RE: PL2019407 – Paragon Star Soccer Complex Final Development Plan

We have received your comments dated December 13, 2019 for the above referenced project. Our responses follow each comment. The comment responses have been organized by the review section they pertain to.

Paragon Star Soccer Complex
Soccer Complex & Associated Improvements
1401 NW View High Dr, Lee's Summit, MO 64081
Final Development Plan - RESUBMITTAL

2020-03-13 PARAGON SOCCER COMPLEX LANDSCAPE WORKSHEET

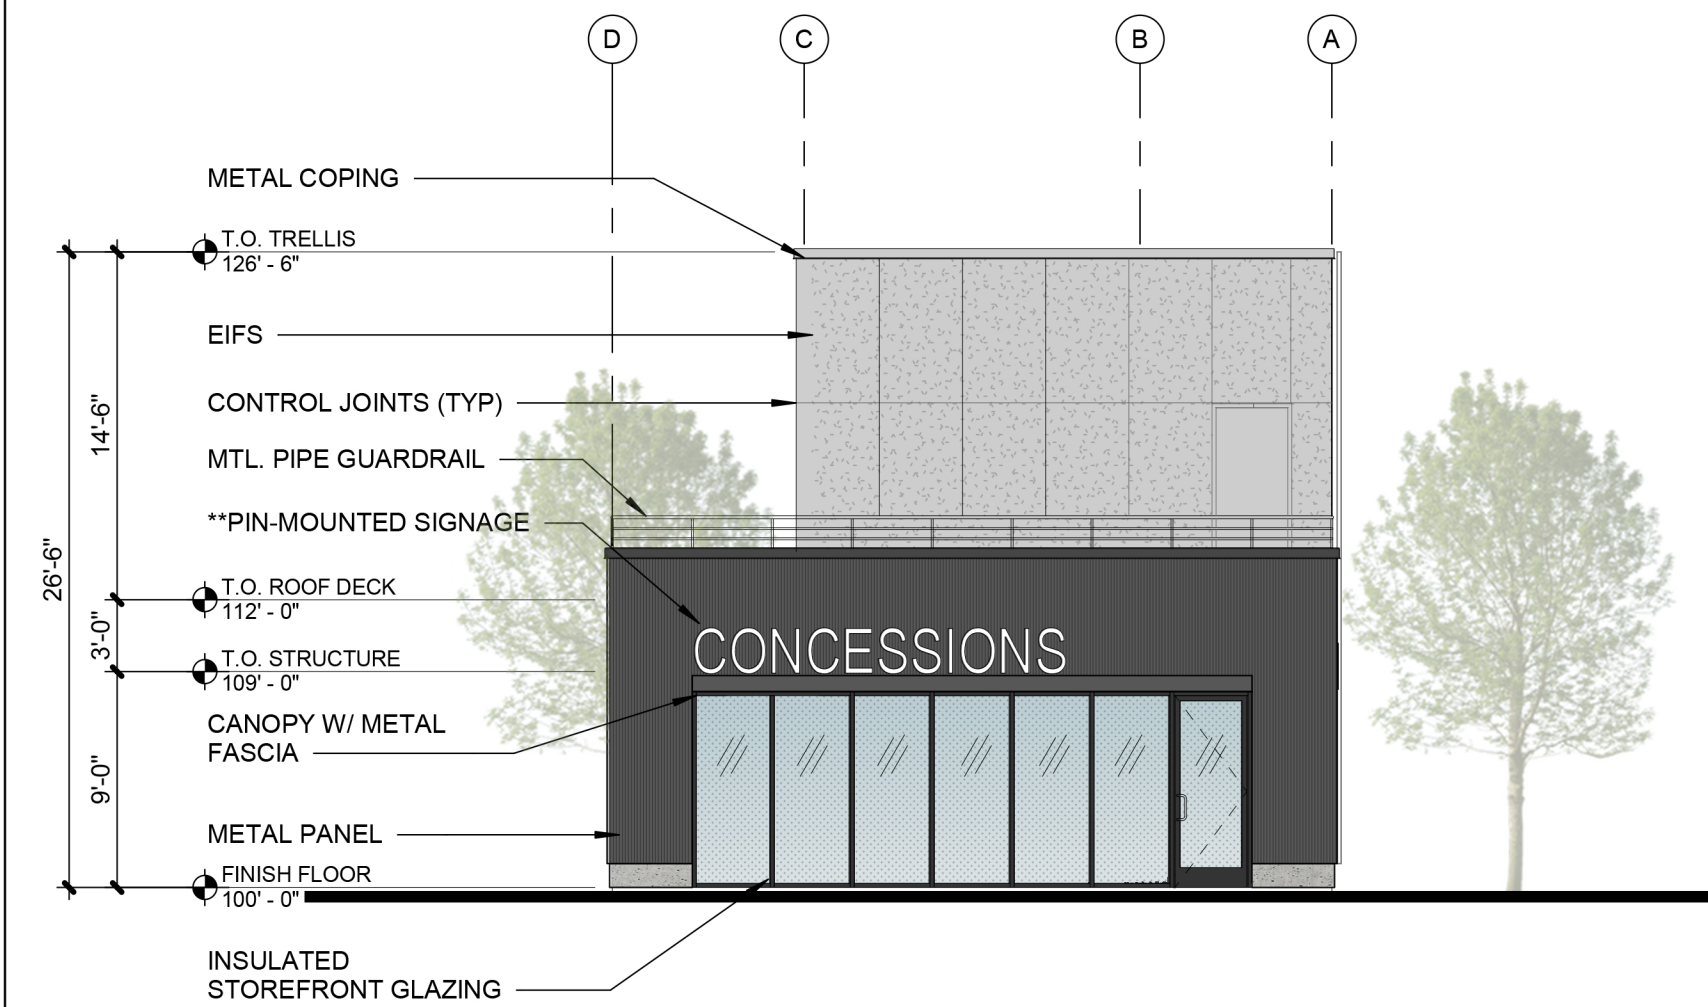
13. A landscape worksheet was not received with this submittal. To better understand the landscaping requirements for the site, please complete the landscape worksheet as provided. Please account for all street frontages and open yard requirements, parking lot screening, etc. for purposes of a building footprint, the soccer fields could be considered a footprint.

Response: Landscape worksheet is attached to this narrative letter and submitted 3/13/2020.

**BUILDING
ELEVATIONS**

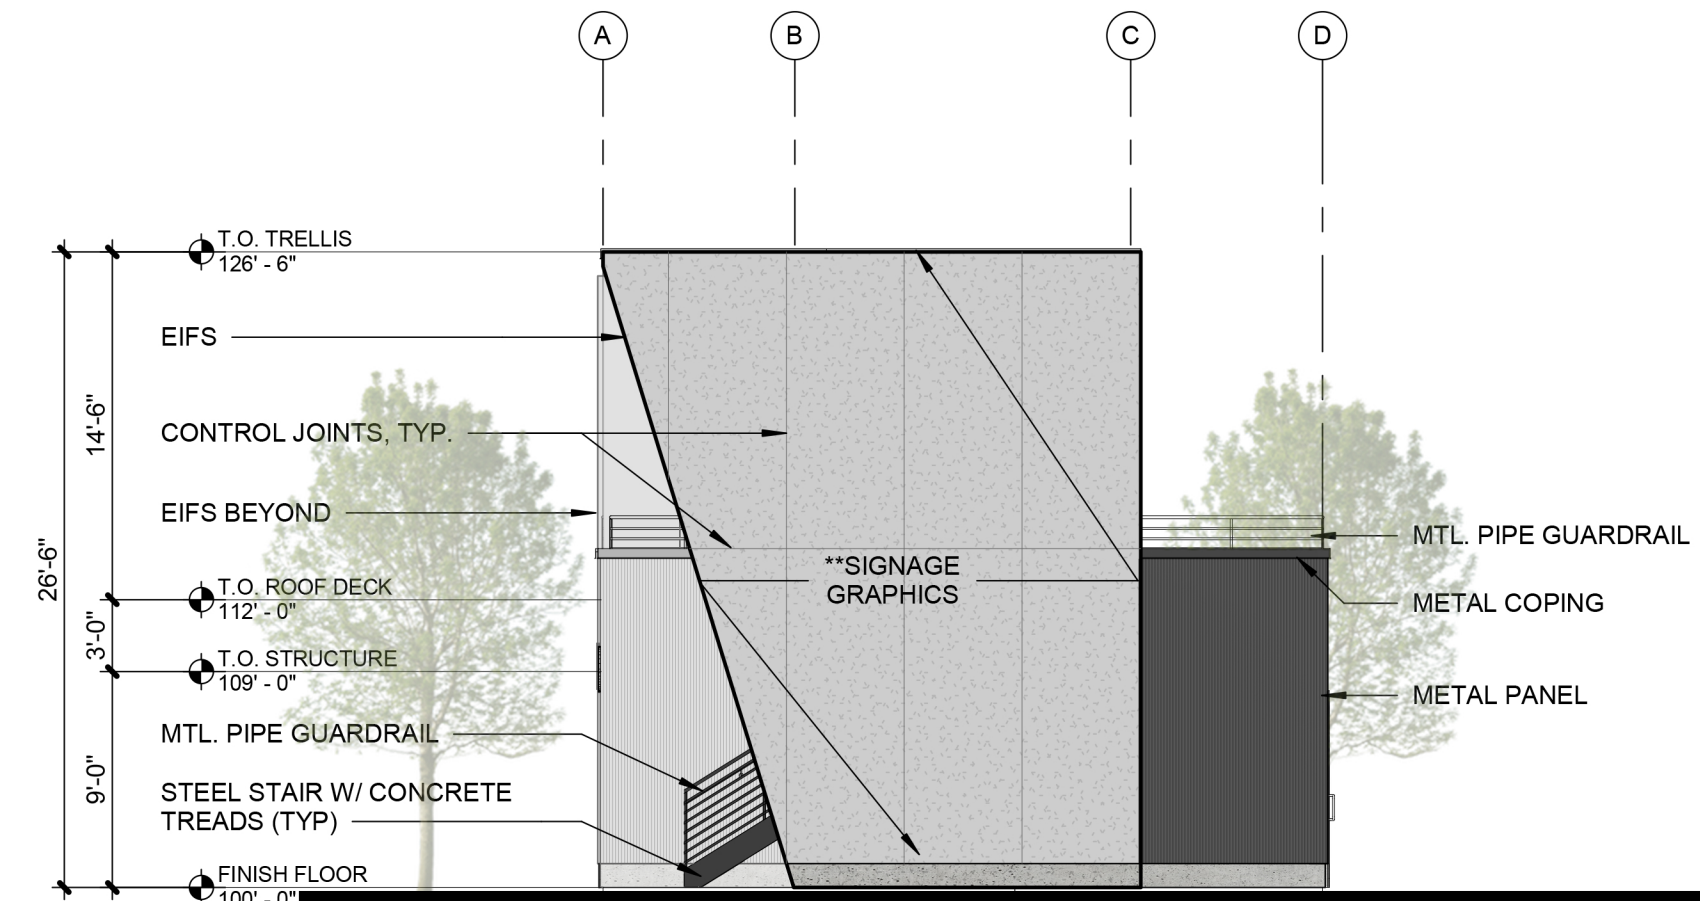
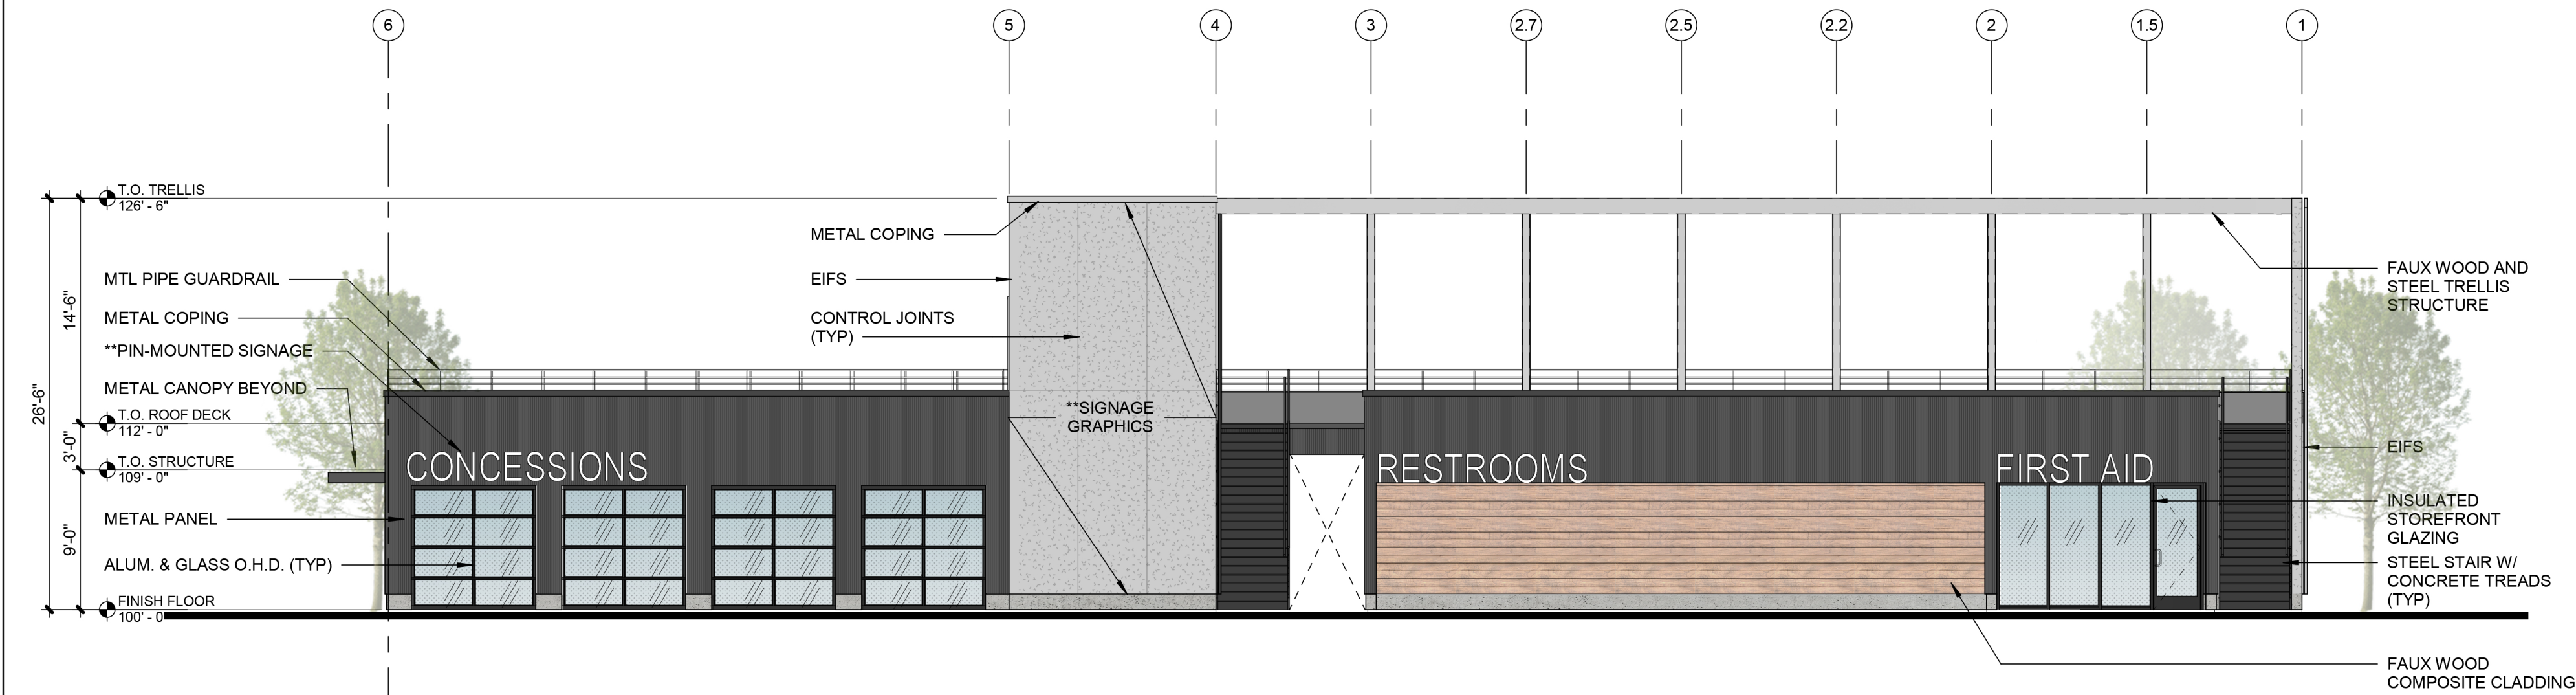
5. Provide the proposed colors for the concession/restroom building

What is the exterior building material on the south elevation under the restroom sign?

6. Indicate on Sheet A2.01 the location of the proposed roof top mechanical units. The units are required to be screened from view by using parapet walls of the same height as the mechanical units.

Response: Specific colors have not yet been selected. The general color palette is as indicated on sheet A2.01, resubmitted 3/13/2020. Full-size print is in black-and-white; 11x17 color print is attached to this narrative. PDF provided on disk is in color.

Response: This material is shown as a faux-wood composite cladding, similar in character to the Paragon Star Village. Note has been added to 1/A2.01, resubmitted 3/13/2020.

Response: The current design intent shows a Mechanical Room per 2/A1.01 that is open-air above and screened on all sides by full-height walls. Note has been added to 4/A2.01 to indicate the access door to the Mechanical Room. No additional mechanical screen (louvers, parapet, etc.) is necessary for screening. These revised sheets are resubmitted 3/13/2020.
